City of Carlisle, Iowa
Planning and Zoning Commission
Regular Meeting
October 16, 2023

RE: PDM Metals Building #2 – Site Plan Review
Project No. 7023.051
City of Carlisle, Iowa (City)

FOX Strand has completed the first review for the PDM Metals Building #2 Site Plan dated October 3, 2023. Please address the following comments:

RE: CTI Ready Mix (2023) – Site Plan Review
Project No. 7023.051
City of Carlisle, Iowa (City)

Sheet C2.1 & C2.2 - Dimension and Landscape Plan

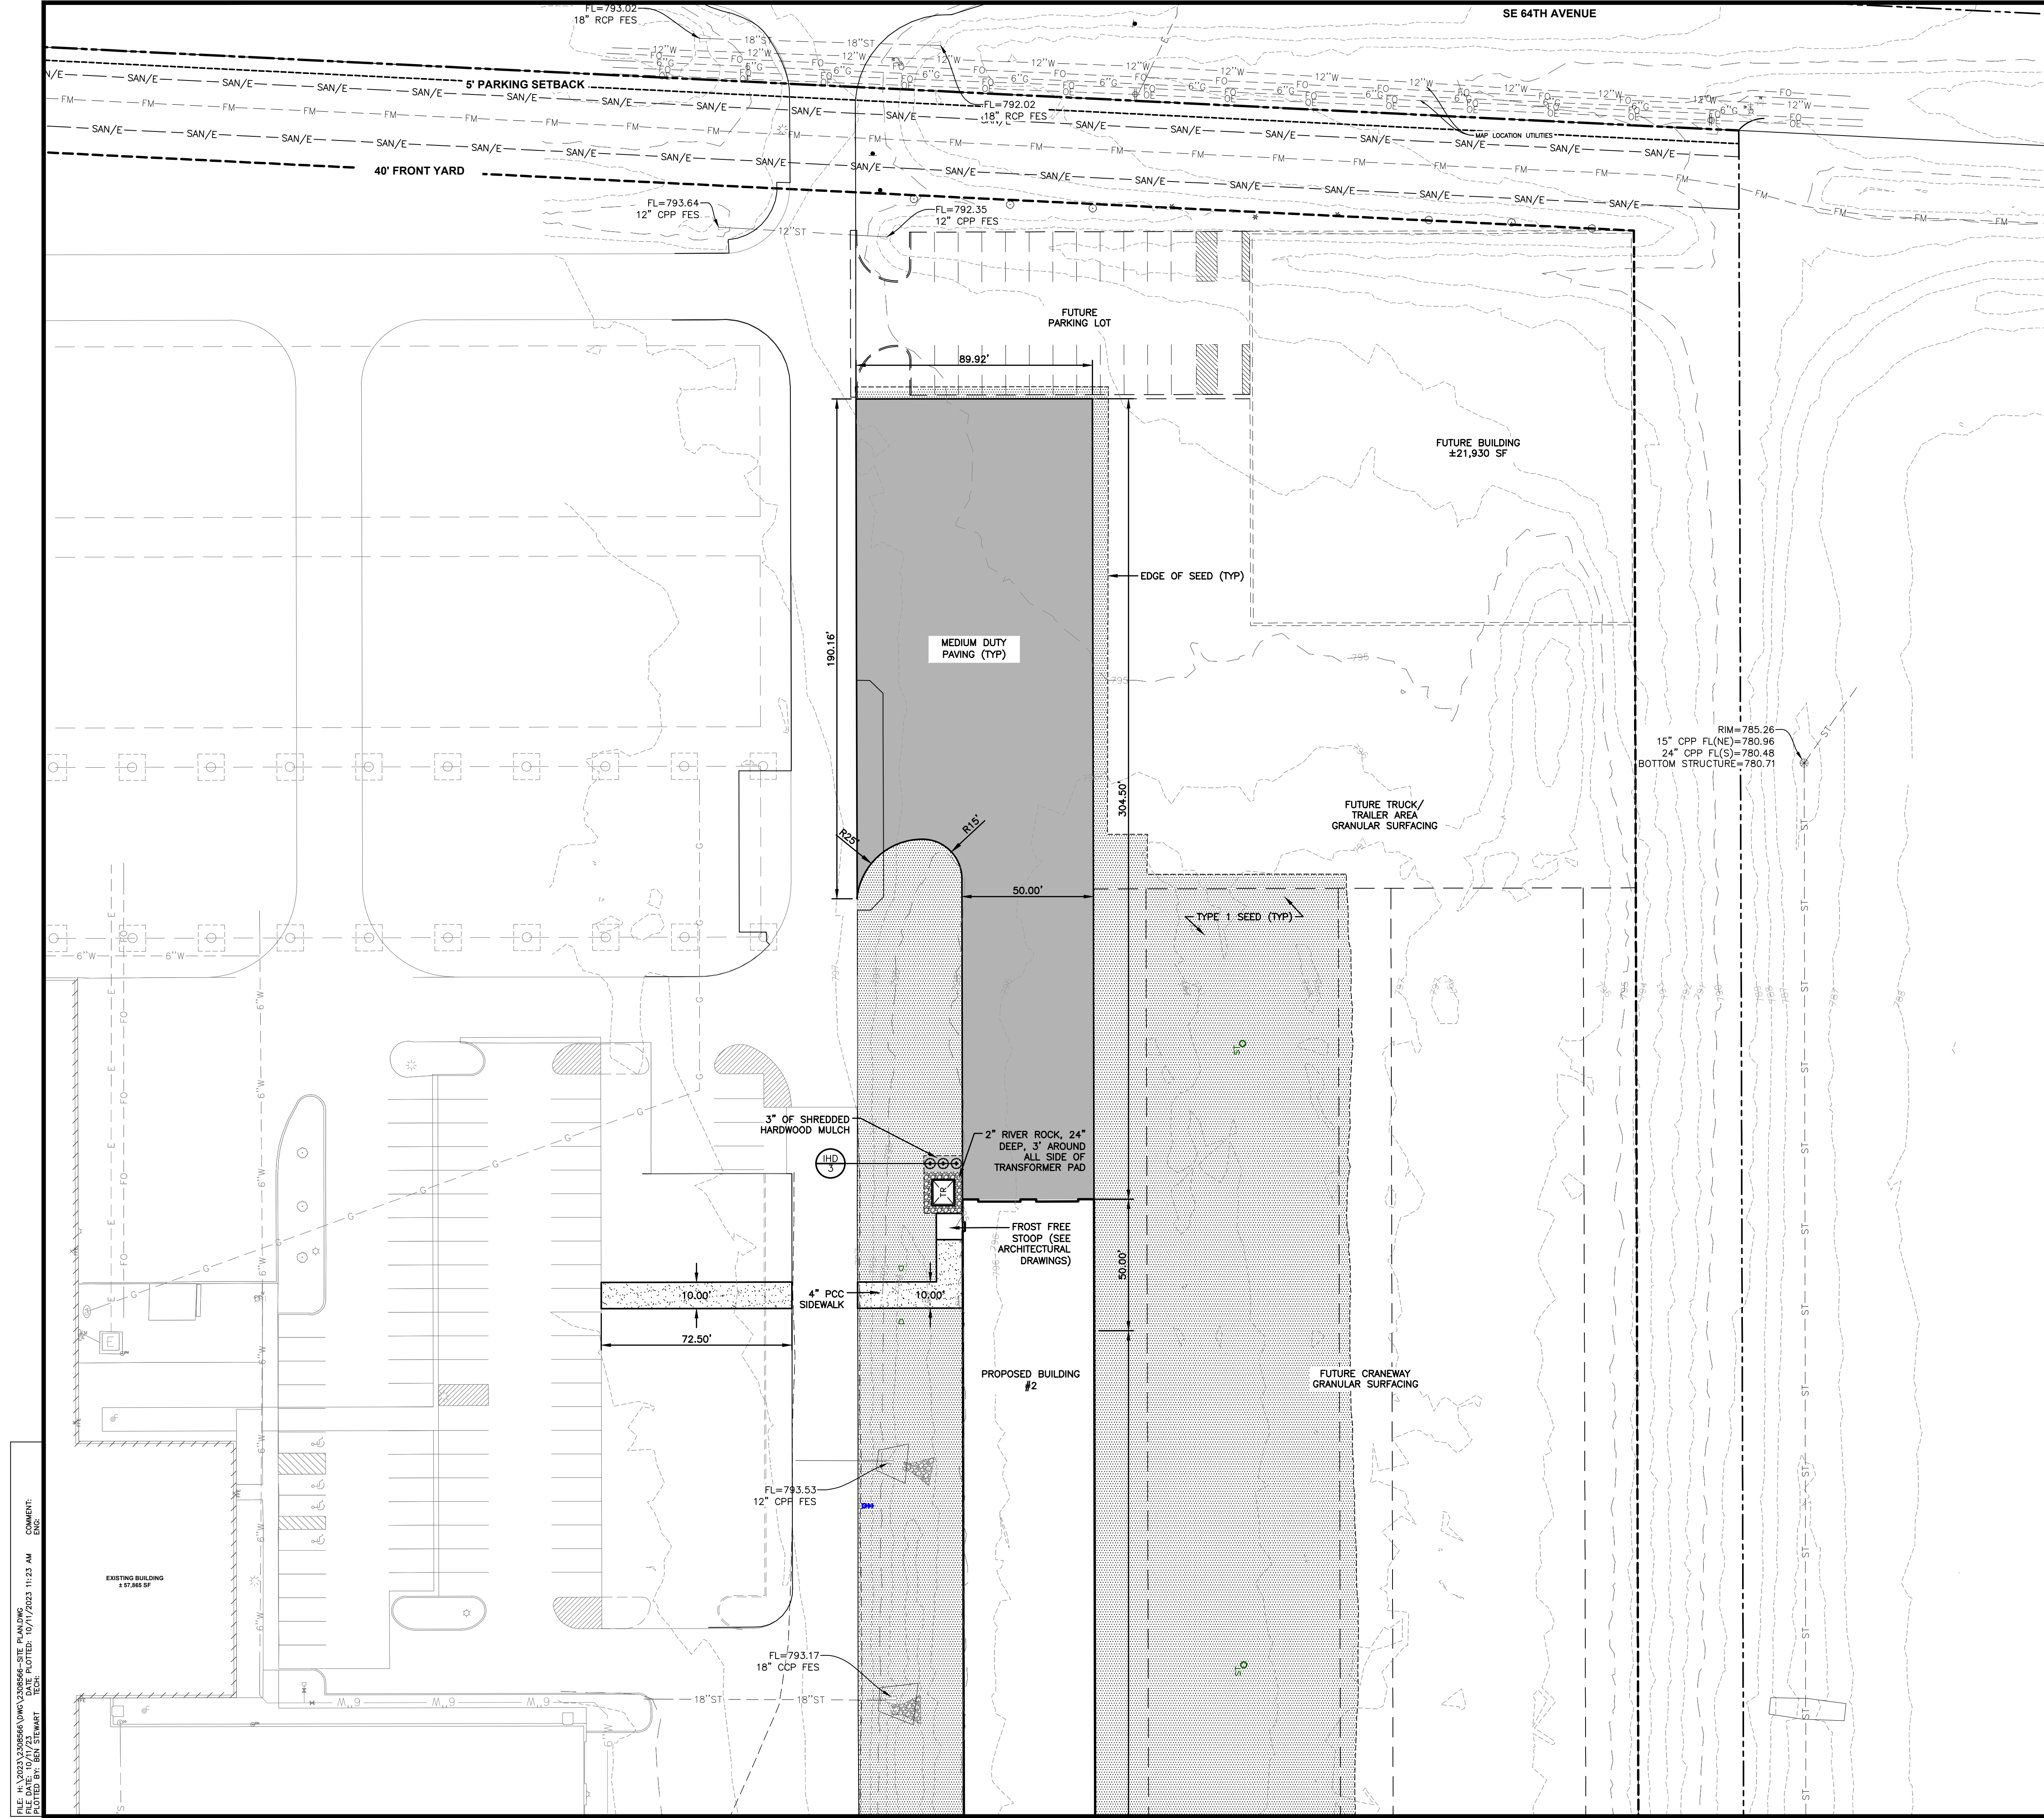
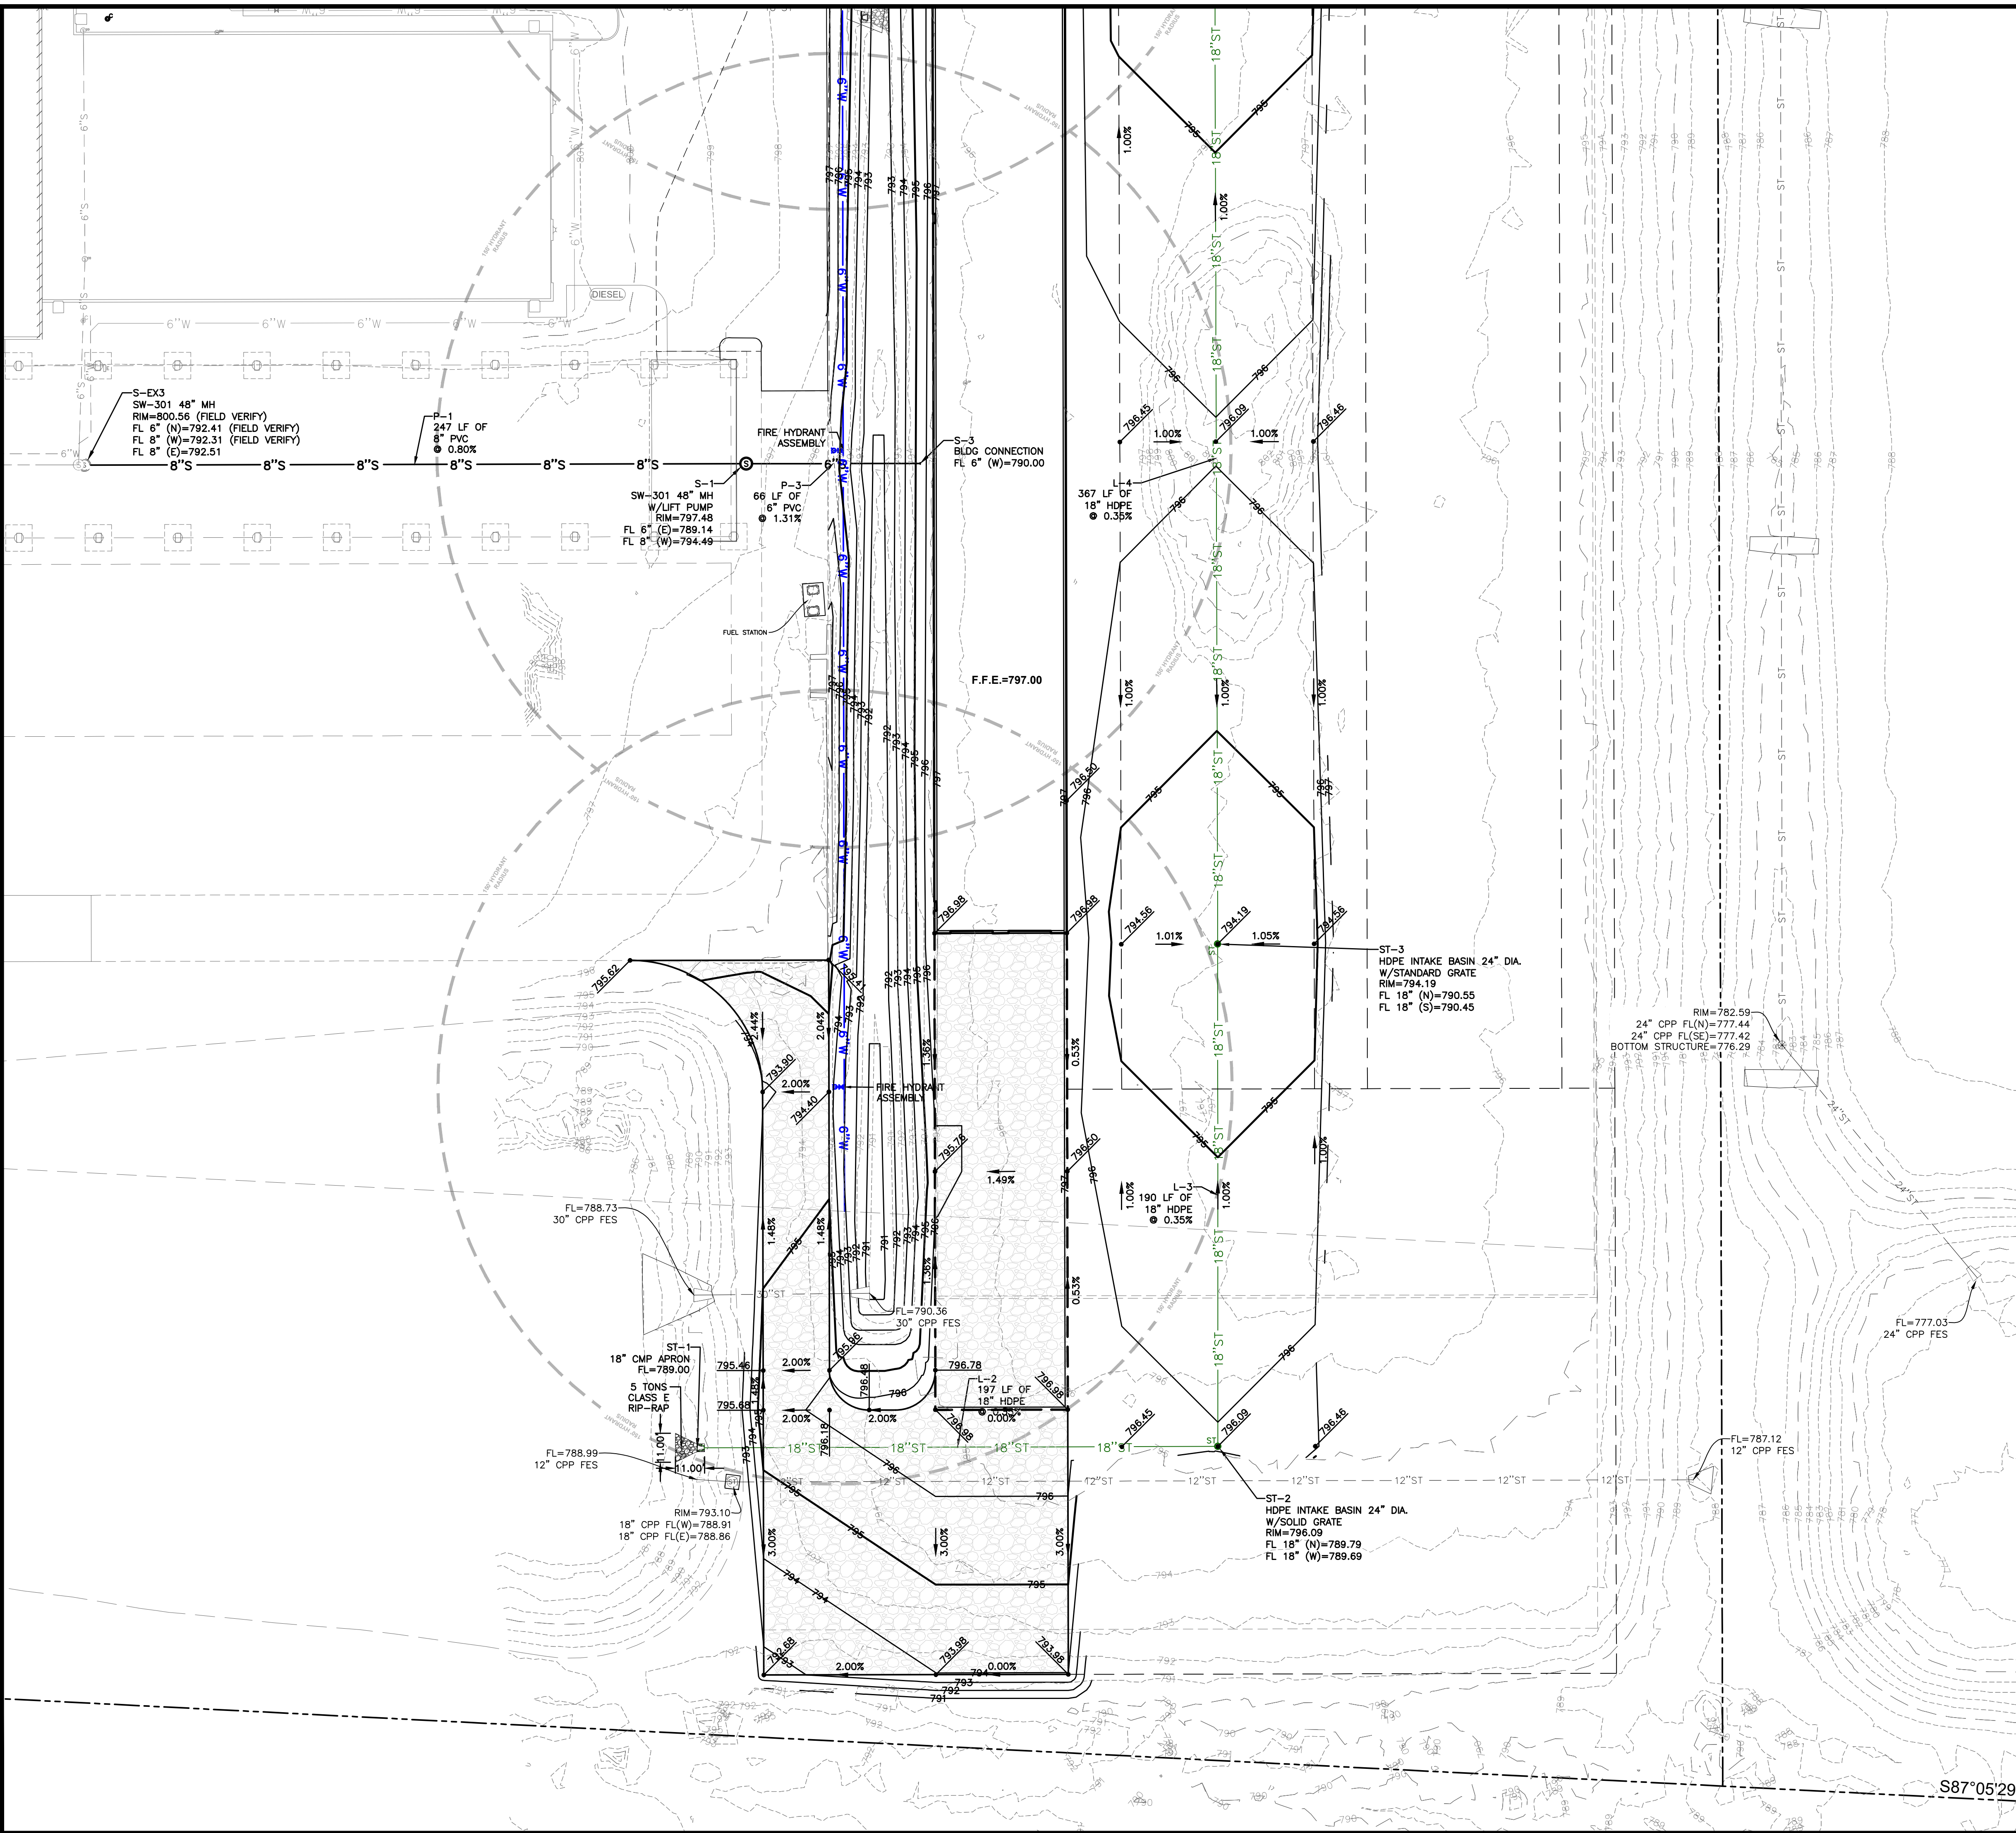
5. Please show/label all man doors and overhead doors on the plan.

Sheet C3.1 & C3.2 - Grading and Utility Plan

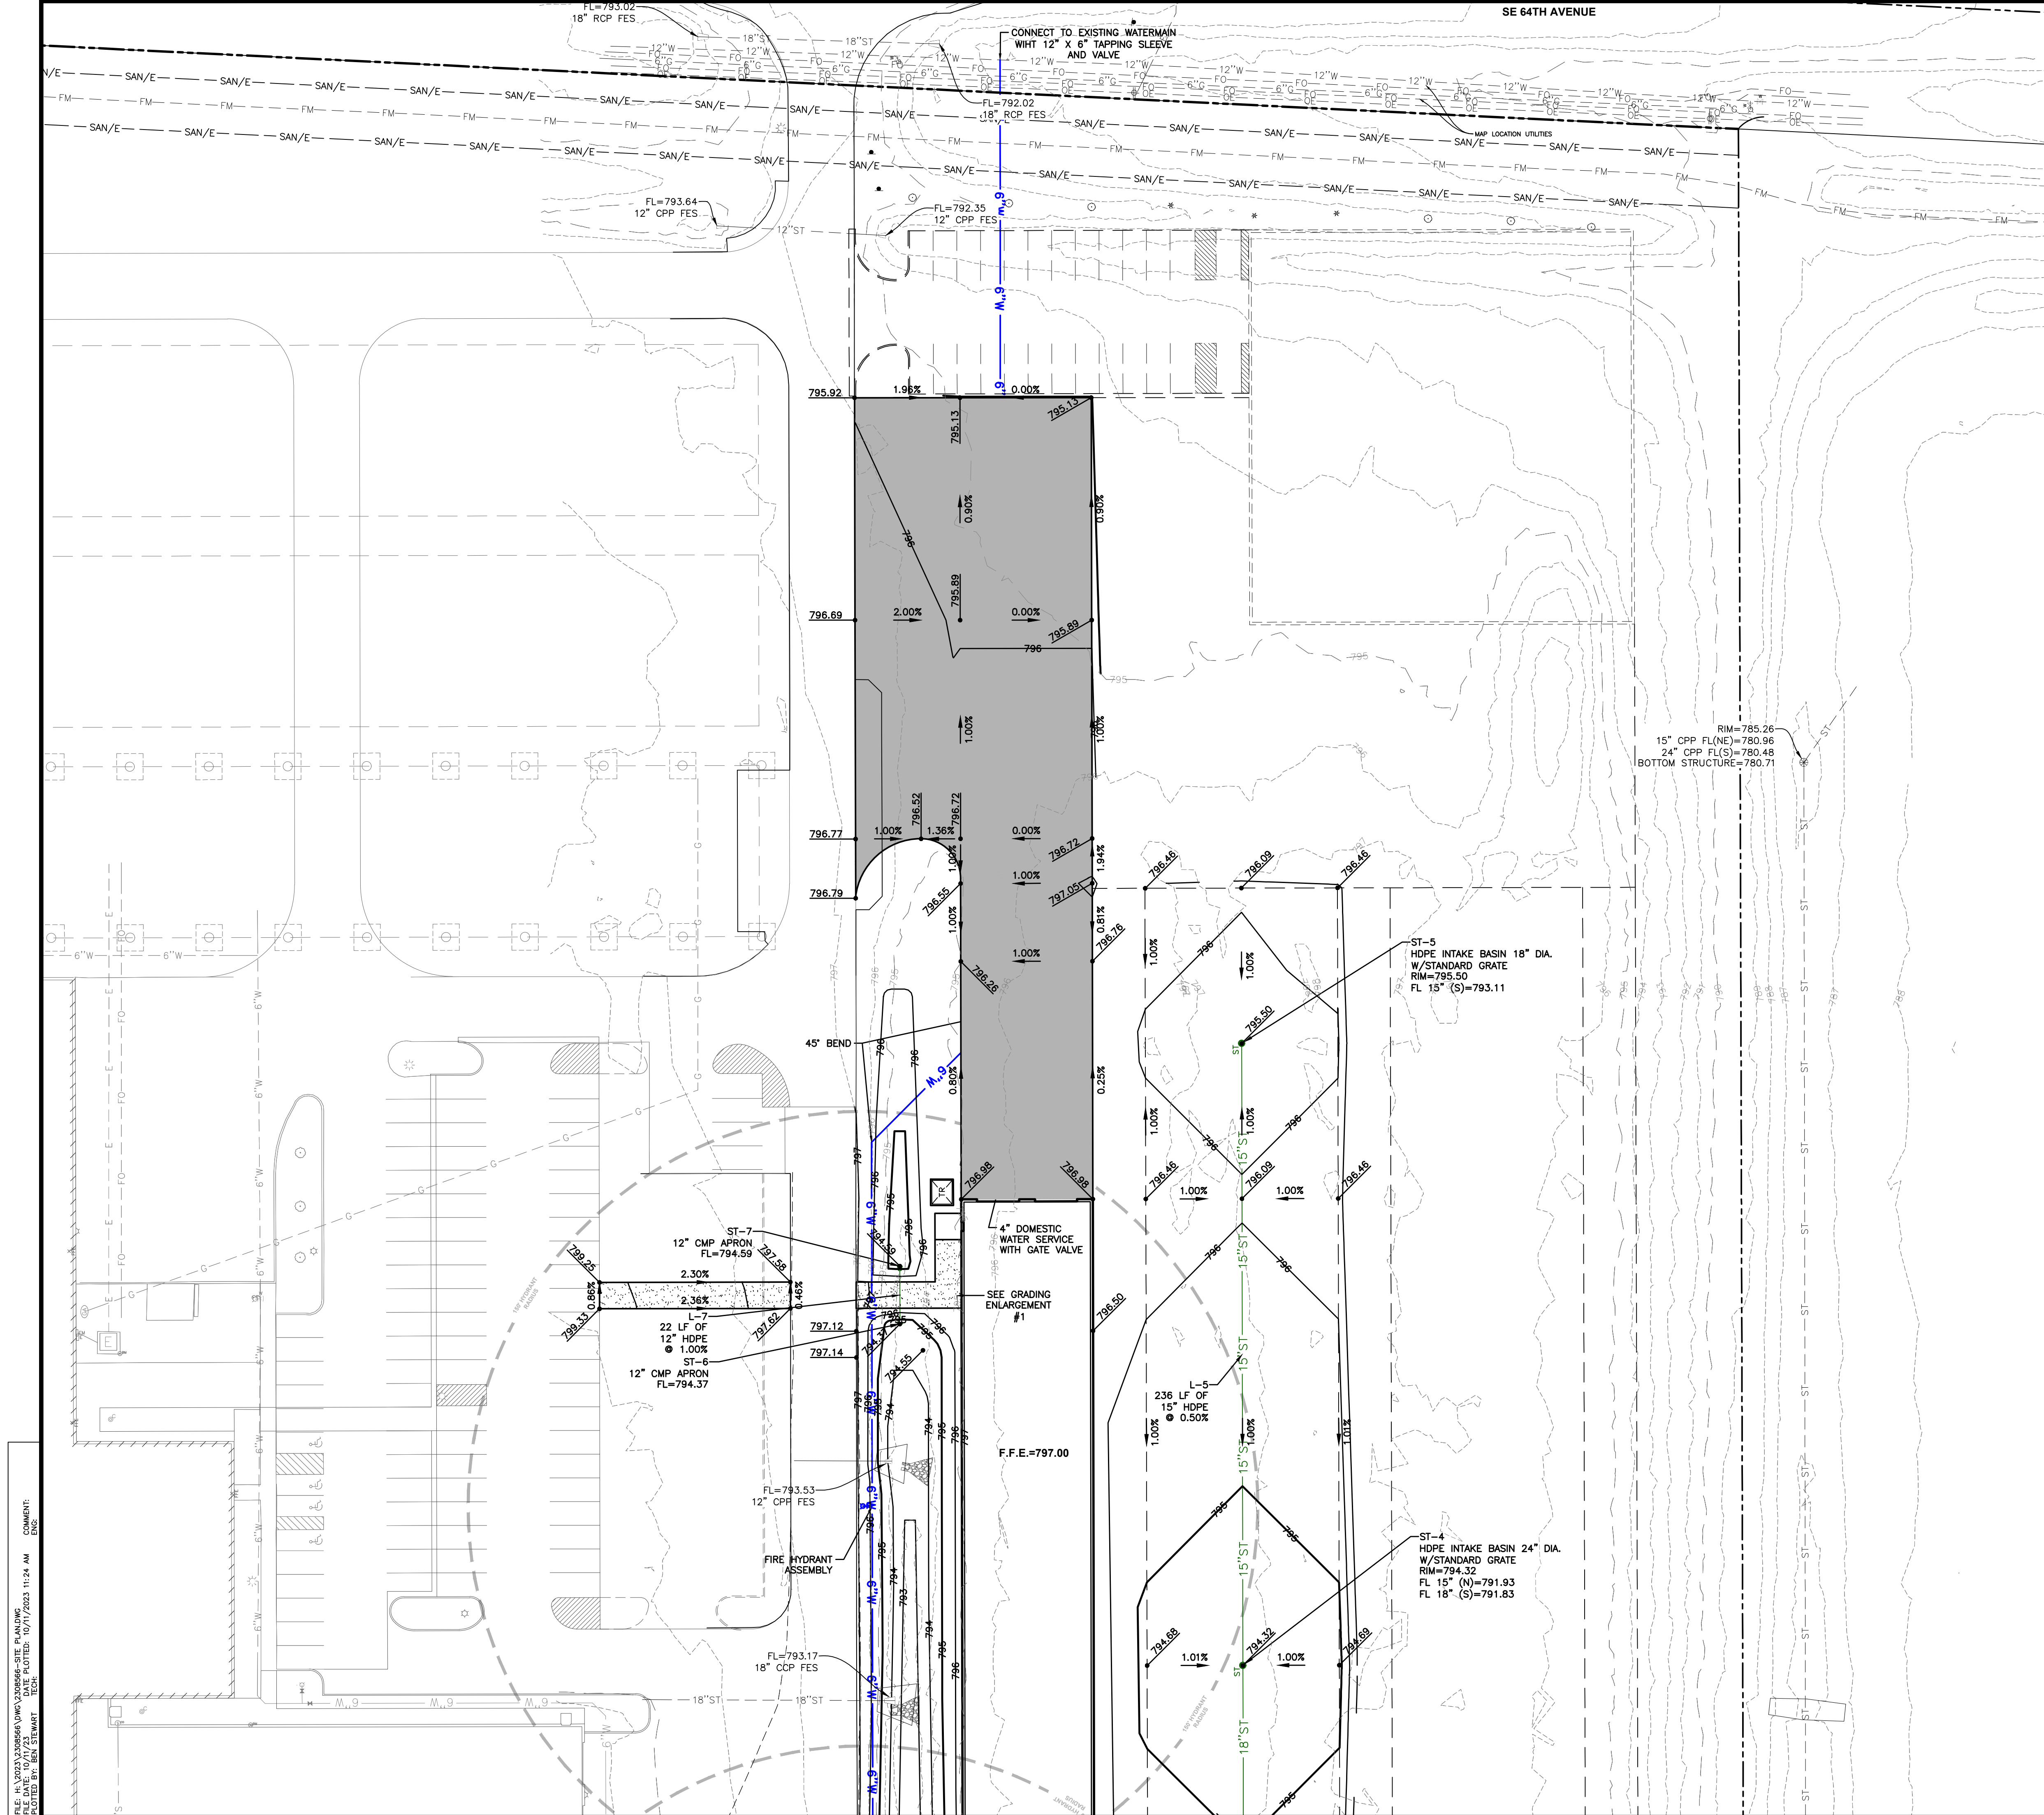
6. Please modify the "order" of the paving hatch at the north end of the site to make the water lines visible.
7. Is there a reason the southern water line is extended beyond the hydrant? Is there a cap at the end? Will this be extended in the future?
8. Please show the location of all downspouts and indicate how water velocity will be dissipated.
